Electrical Panel Replacement

Meadowbrook Apartments, 1408 NW Richmond Beach, Shoreline, WA 98177

ADDENDUM NO. 1

CONTRACT NUMBER: DW2403031

Typical 3-Bedroom Unit Panel

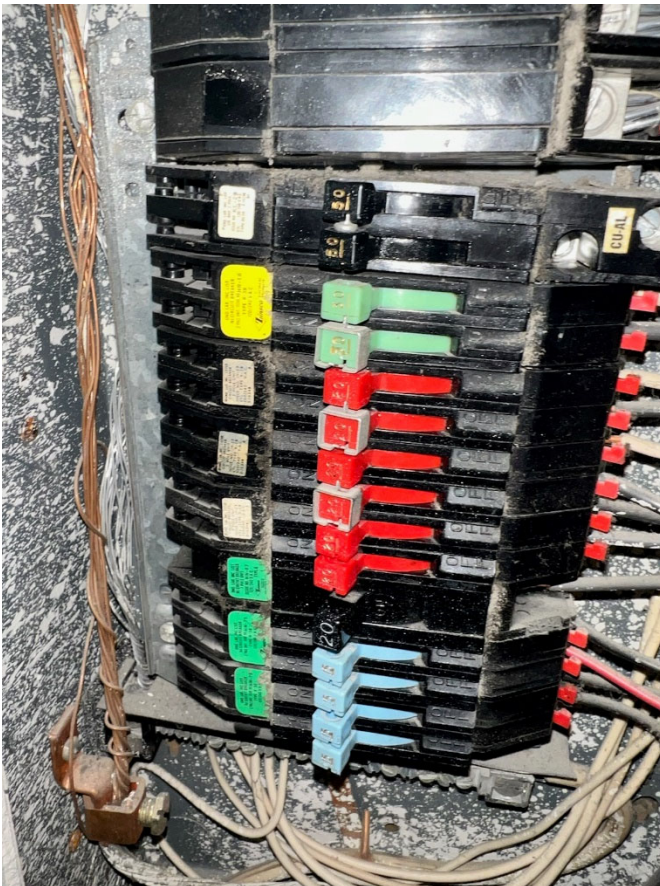
DA 1.2 TYPE AND NUMBER OF BREAKERS

Bidder responsibility to determine the number and types of breakers based on the photo provided.

For bidding purposes assume one less 2-pole, 20-amp breaker the for 2-bedroom and the one-bedroom units.
